**Proposed Temporary Shop and Services and Public Vehicle Park
(excluding Container Vehicle) with Ancillary Facilities and Associated Filling of Land
for a Period of 5 Years in "Village Type Development" Zone,
Lot 354 in D.D. 112, Shui Lau Tin, Shek Kong, Yuen Long, New Territories**

(S.16 Planning Application No. A/YL-SK/454)

Response-to-Comment (RtC)

Drainage Proposal

Figure 3 – Proposed Drainage System

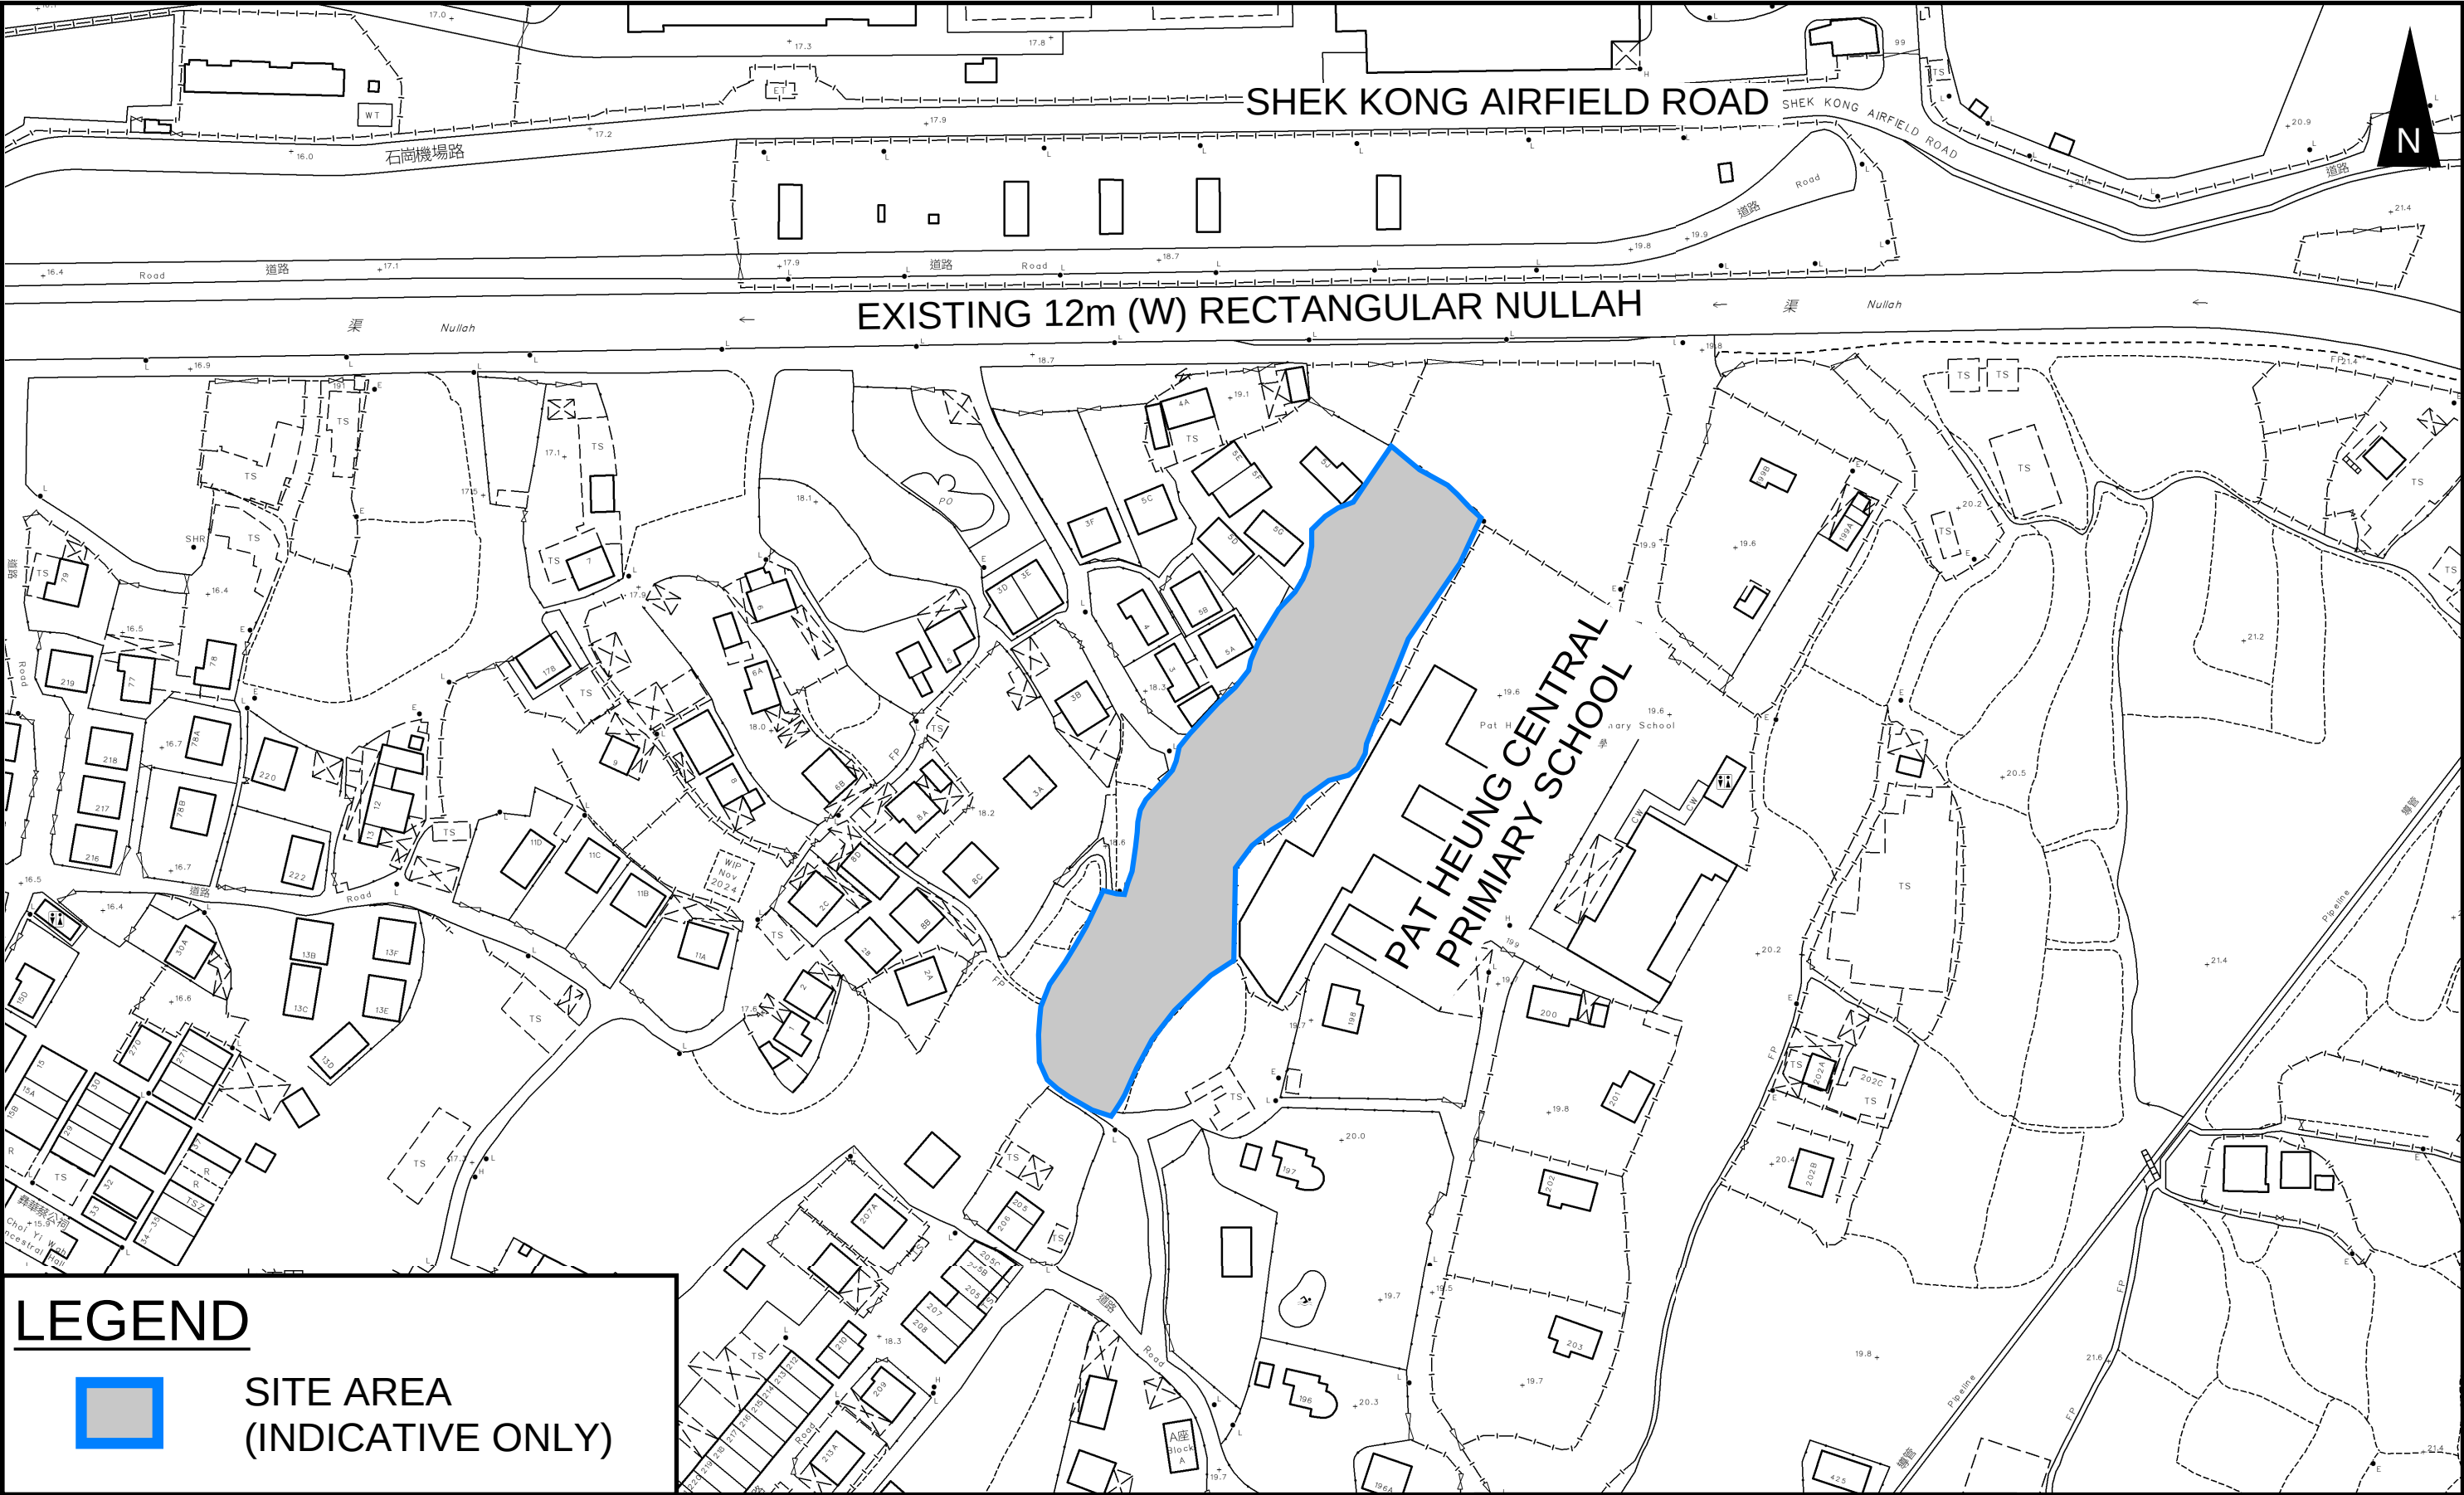
(b)	CP 1.05 to be within private lot and provide sand trap before discharge.	Noted. Figure 3 has been updated (Annex 1). The location of CP1.05 has been revised to situate within the private lot. Catchpit with sand trap is proposed at CP1.05.
